Planning Commission Staff Report

Subject: Rezoning Vote Report

Petition: P.Z. 29-2006 Wildhorse Bluffs (Wildhorse Partners, LLC)

**WIND HORSE BLUFFS
PRELIMINARY SITE DEVELOPMENT PLAN**
Prepared For:
ICG INC.
1600 HERITAGE LANDING, SUITE 112
ST. CHARLES, MO 63303
314.406.3621
122 N. Kirkwood Road
Kirkwood, MO 63122
Tel: 314.952.6286
Fax: 314.952.7592
Email: wind@windengr.com

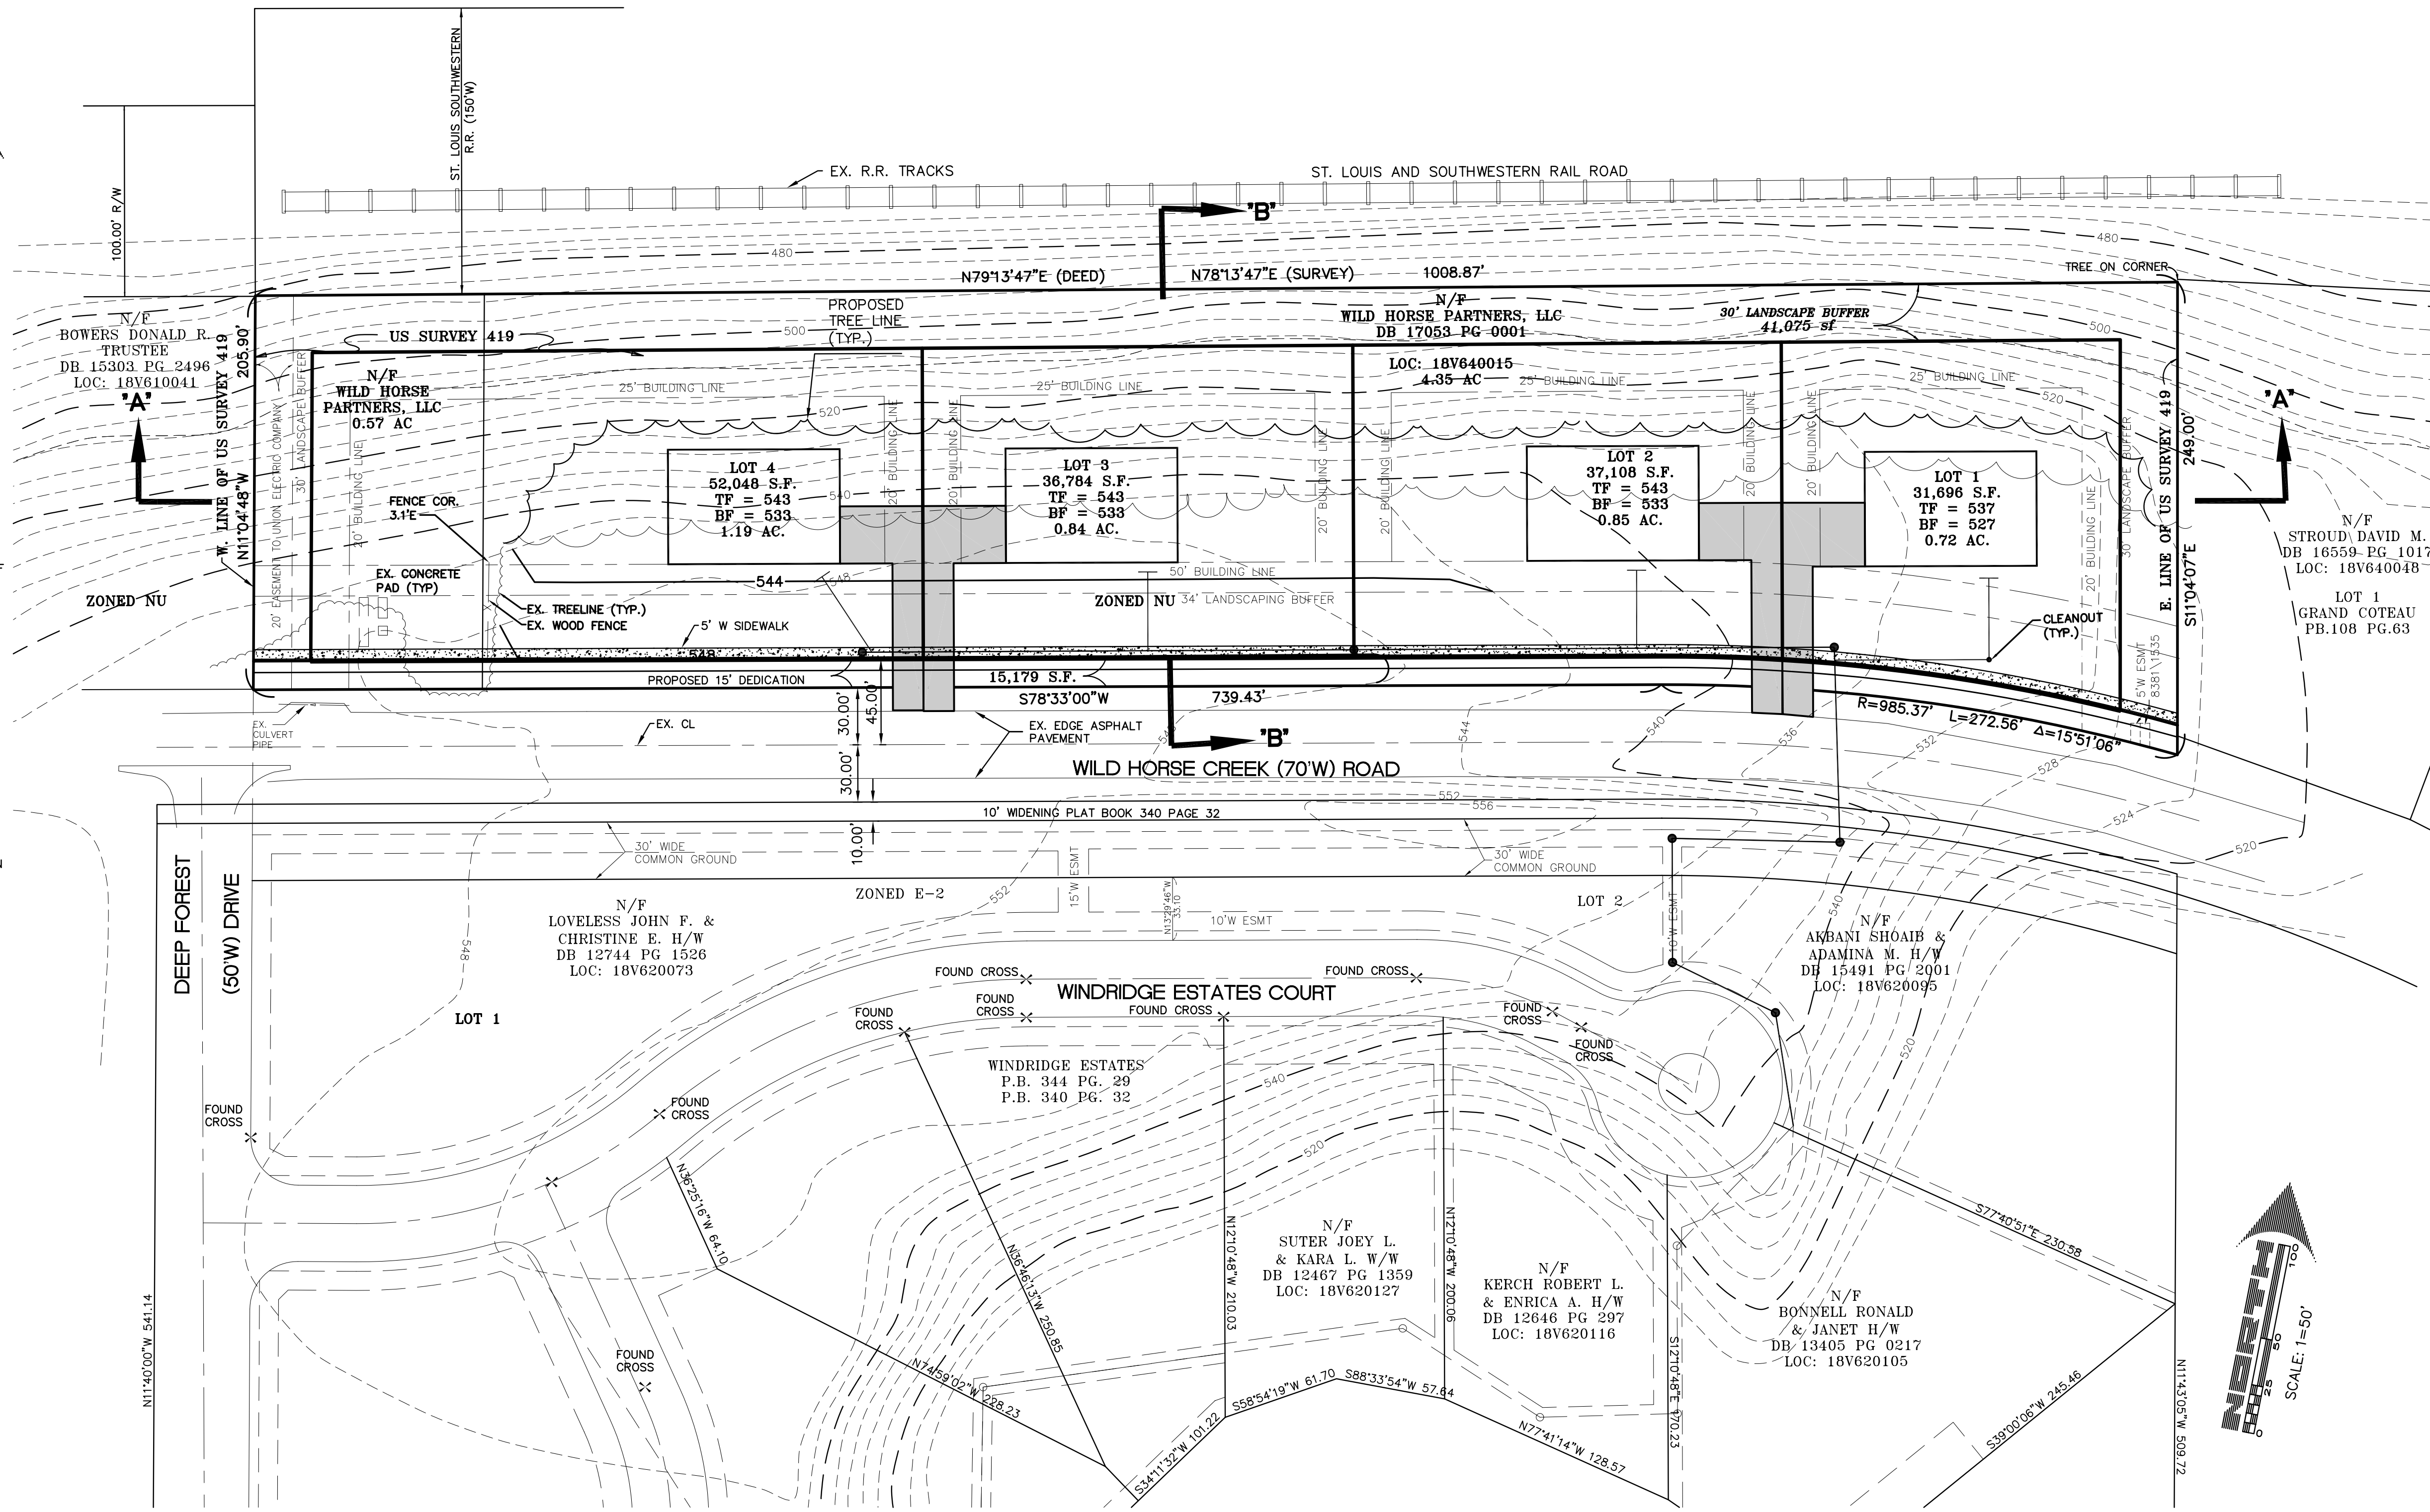
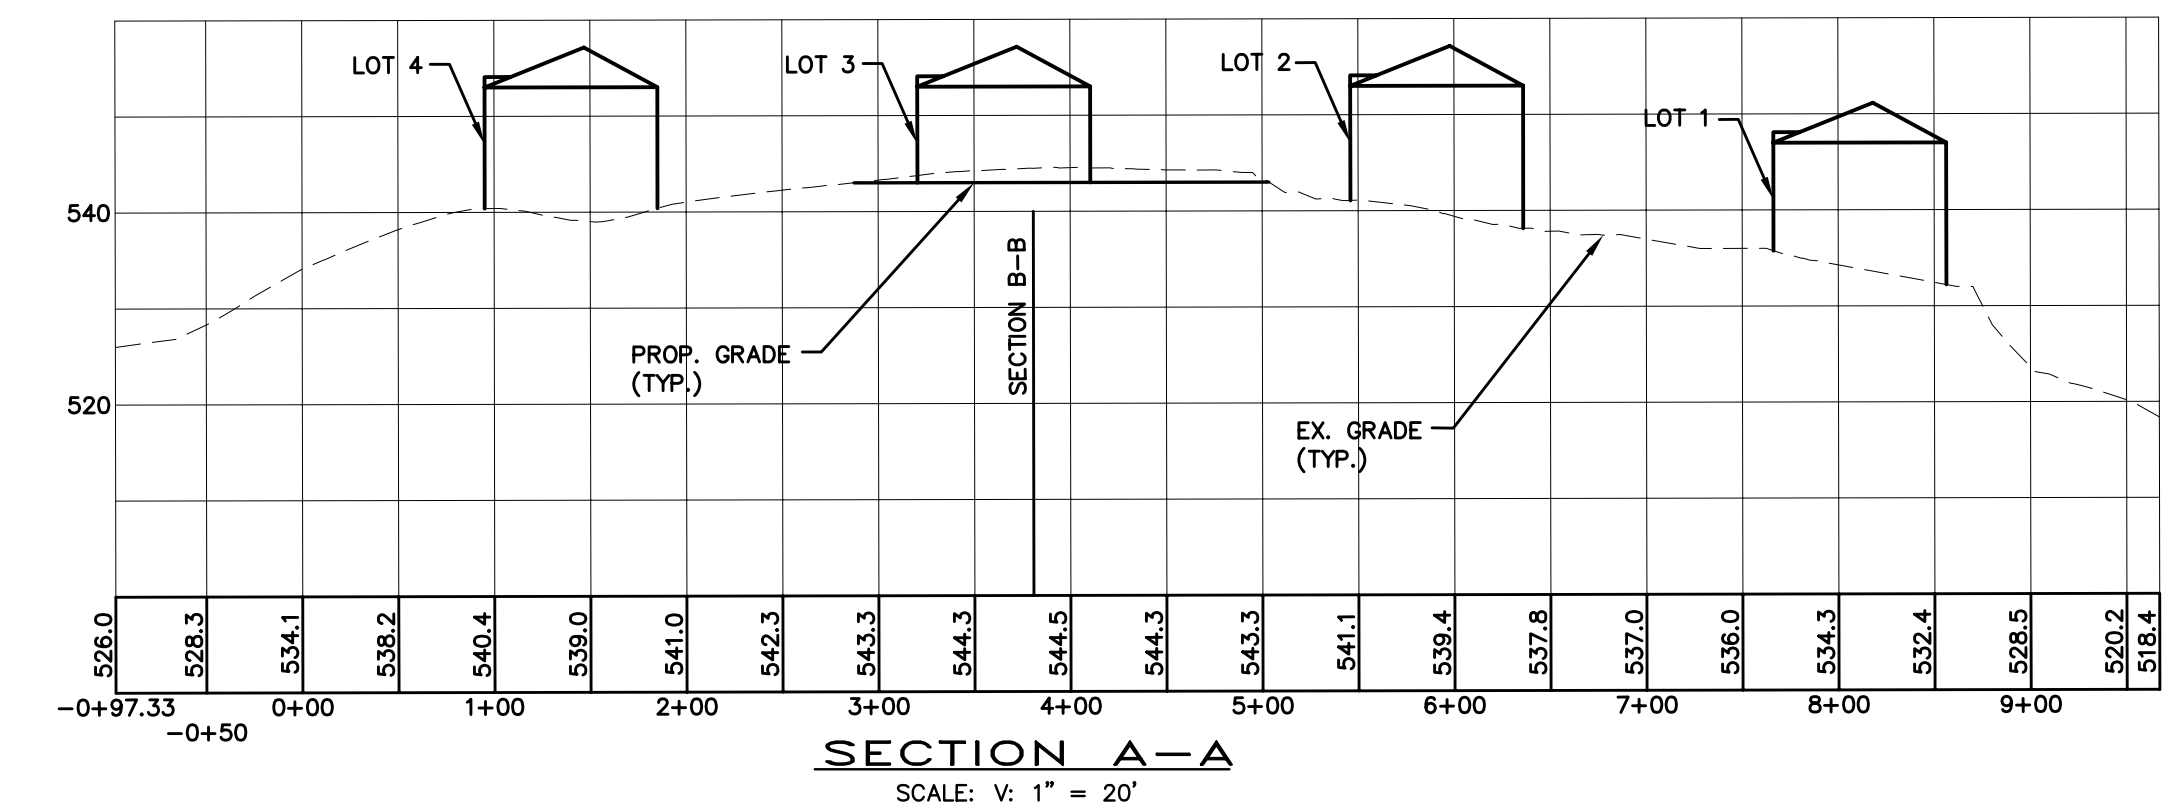
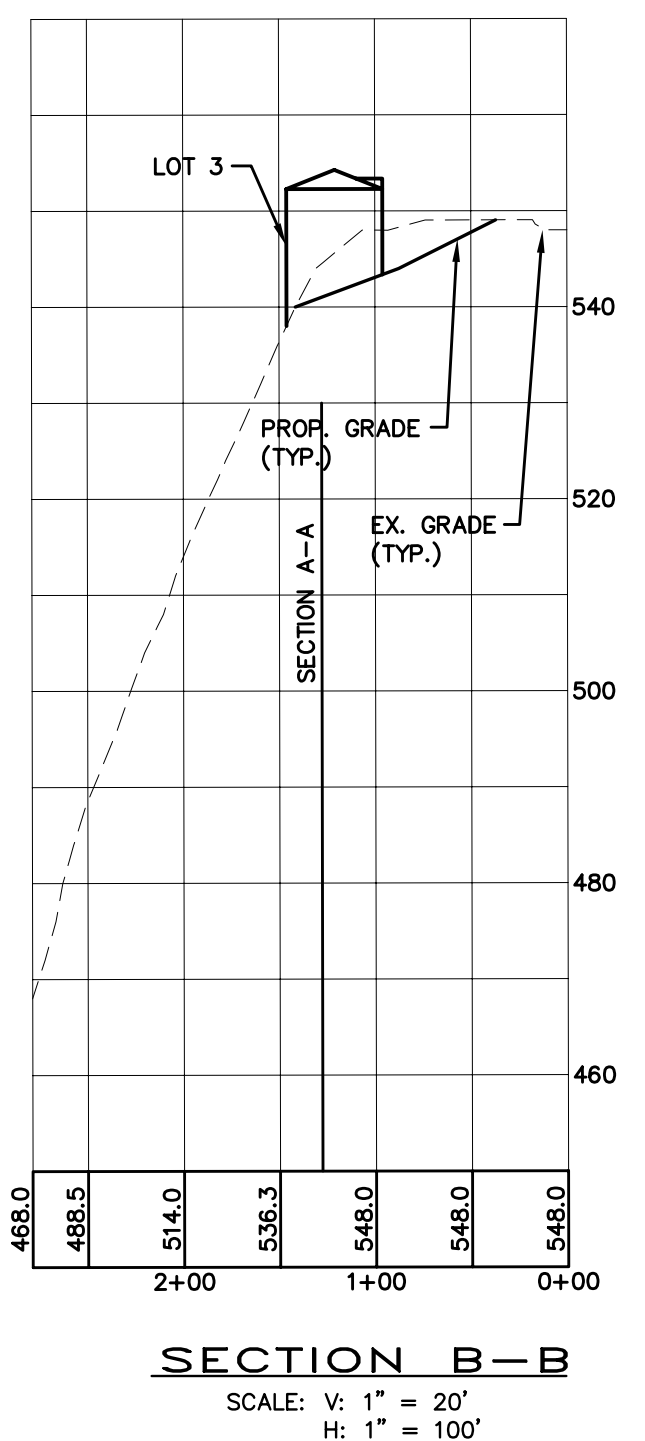
1. Will the monarch tree labeled number 83, on the Tree Stand Delineation submitted on November 29, 2006, be saved?

2. The Tree Stand Delineation referenced above shows a tree labeled 83A on the plan but the same tree is not listed in the tree inventory. Please clarify.

3. How long are the shared driveways?

5. How feasible is it to change the two shared driveways into one shared driveway for the four houses?

11. Per City of Chesterfield Ordinance 2275 an 80 foot structure setback from Wild Horse Creek Road is required.

12. How much of the development will be built on the bluffs?

13. Be advised that City of Chesterfield Ordinance 2275 requires that 70% of all areas exceeding a 30% slope shall be protected and shall remain without development.

It is the developer's intention to preserve this tree.

The arborist tells us this tree is a hard maple.

From the curb line, each of the shared driveways is approximately 80 feet in length.

This change is not feasible.

According to the Planning Department's interpretation of the ordinances, a combination of a fifty-foot setback and a thirty foot setback would be required. From the outset of this proposal, however, we informed the City that we needed an exception to this rule that would recognize the fifty foot setback but not the additional thirty feet. Before this proposal was even filed with the City we met with the two members of the City Council who represent this area. Immediately after filing, we met with the planning staff. At all times this difficulty was known. It has been consistently acknowledged by all parties that the exception is required by the topography of the site, and that therefore, our request for an exception is not based on mere convenience or to seek to maximize density. We continue to anticipate the necessity of such an exception.

The rear 25 feet of the houses on lots 3 and 4 will minimally impact the bluff.

The bluff is the only part of the property with a slope of 30% or greater. The impact as described in response to issue #12 is to only 10% of the bluff, leaving 90% protected.
